VIRGINIA WATER DRIVE EXT - PLAN-PROFILE
WALLBROOK ROADWAY IMPROVEMENTS
 VIRGINIA WATER DRIVE EXTENSION (SERVING LOTS 9-11)
 Town of Rolesville Project No. CID 23-
 US 401 Business / S. Main Street & Virginia Water Drive
 Wake Forest Township, Wake County, North Carolina

C3.0

ACCESS DRIVE - PLAN-PROFILE

C3.1

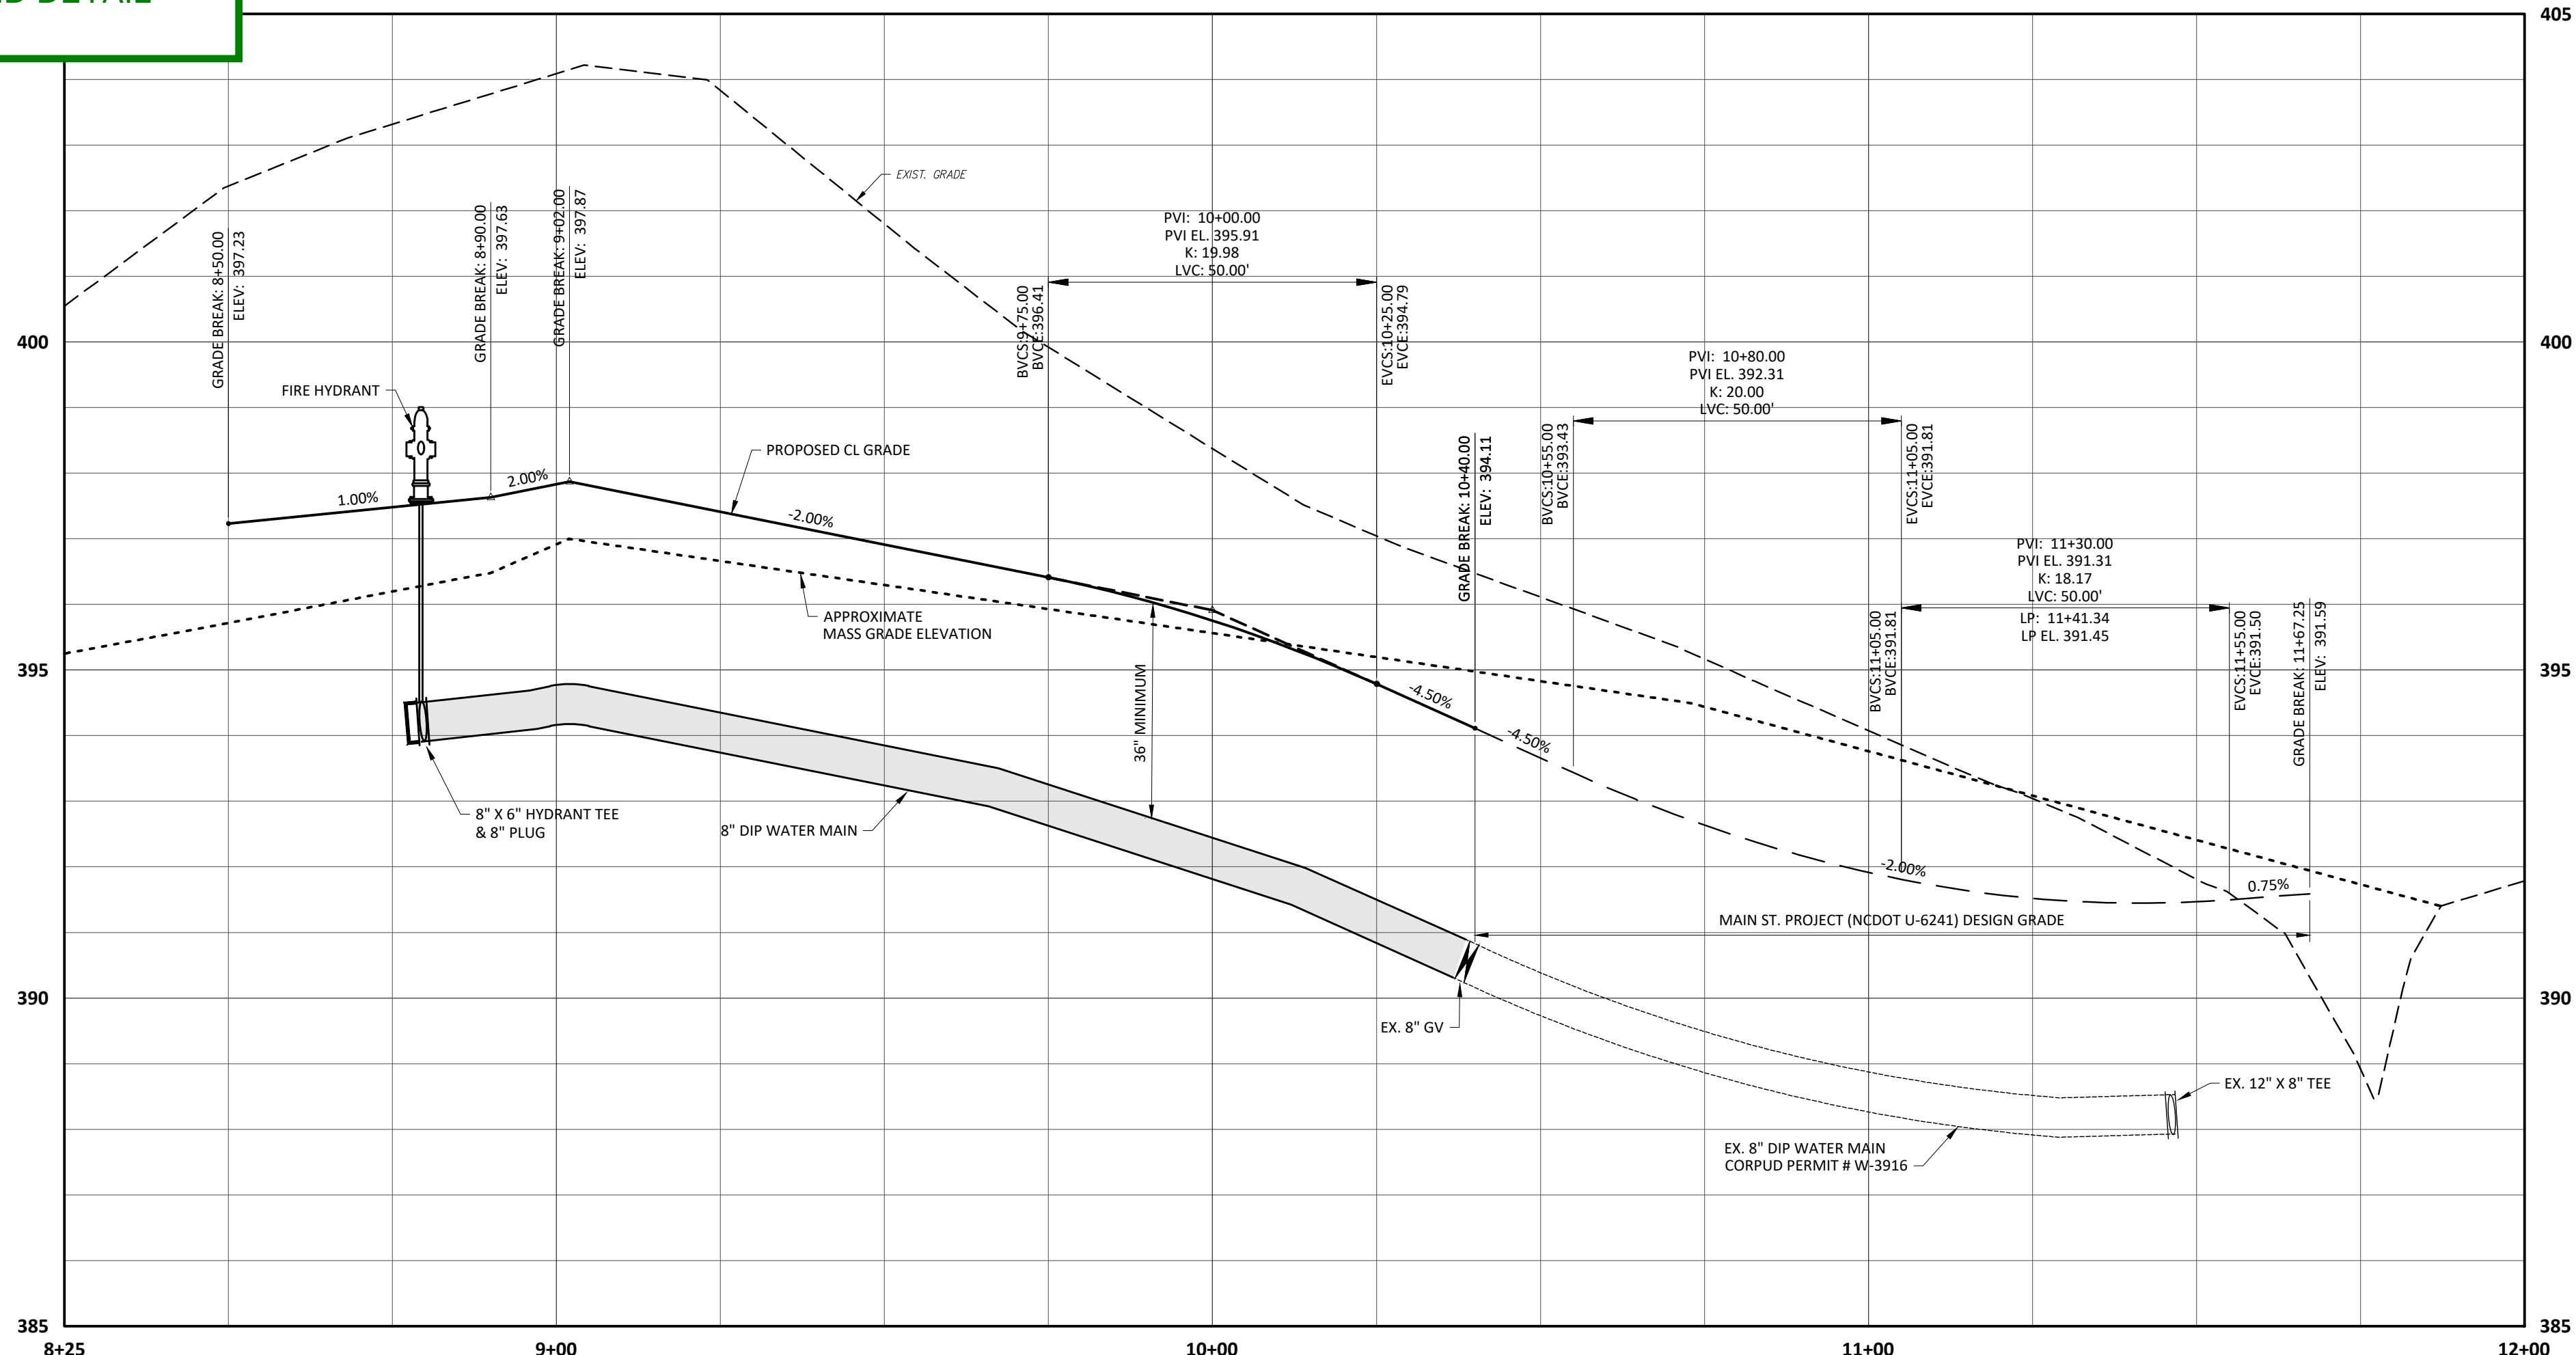
The waterline will need to terminate with a 8" blow off assembly. Also, CORWLE should be extended 5' on each side of the FH from the R/W.

EASEMENT ADDED. BLOWOFF NOTE ADDED AND DETAIL ADDED TO C4.1.

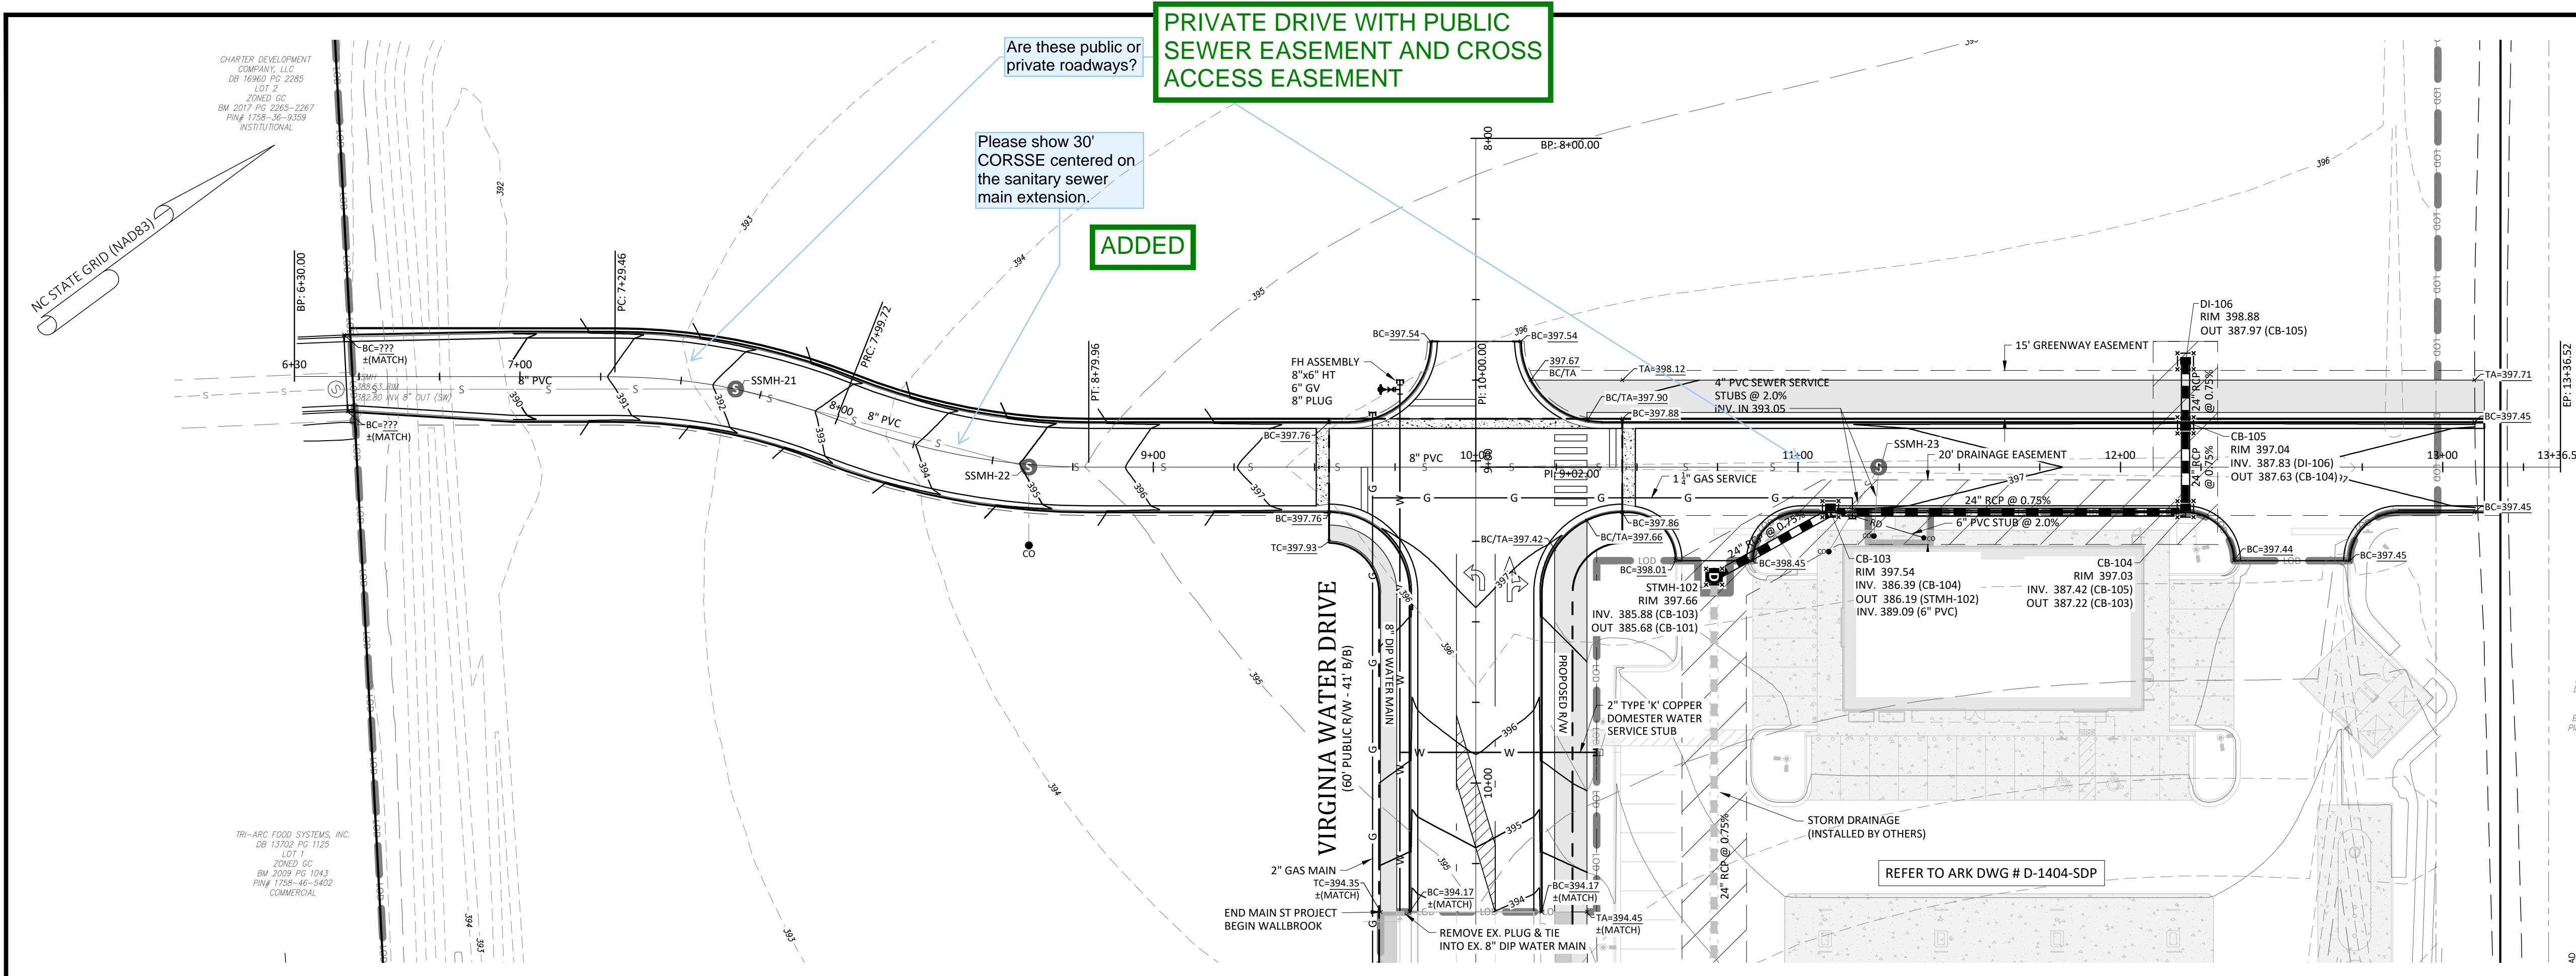
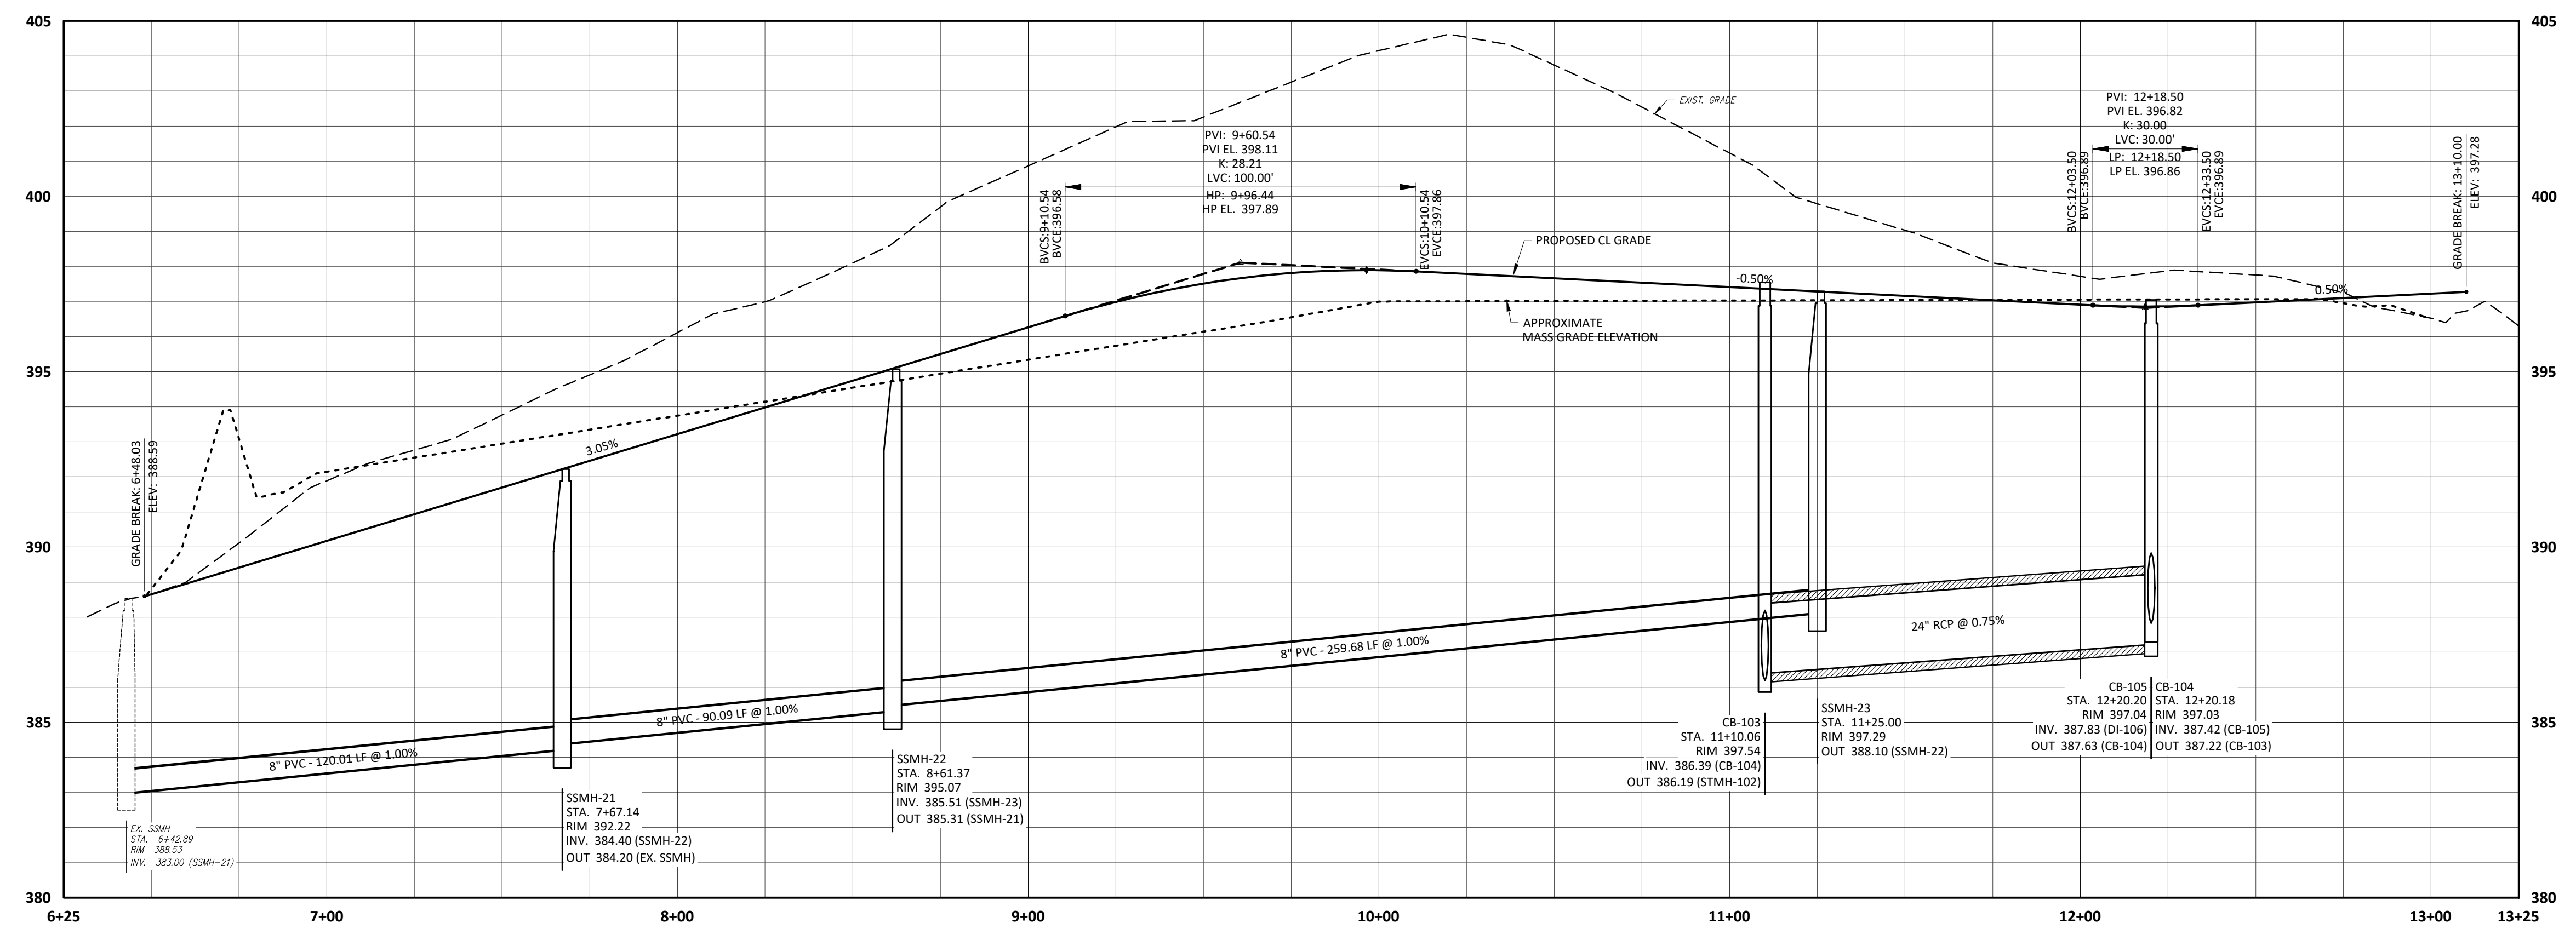
Are these public or private roadways?
Please show 30' CORSE centered on the sanitary sewer main extension.

The intent of these CDs may not be to subdivide these parcels but the master plan clearly shows a subdivision with 3 lots. Please clearly show the lots lines for all 3 of these lots so that it is demonstrated that all 3 will have access to public water and sewer. For example, if the east and west roadway extensions are private, you'll need to demonstrate that public sewer easement touches each parcel so that they will have access to sanitary sewer.

ADDED

PUBLIC SEWER EASEMENT AND CROSS ACCESS EASEMENT EXTENDS TO ALL THREE PARCELS. ADDITIONAL LABELS ADDED ON SHEET C2.0.
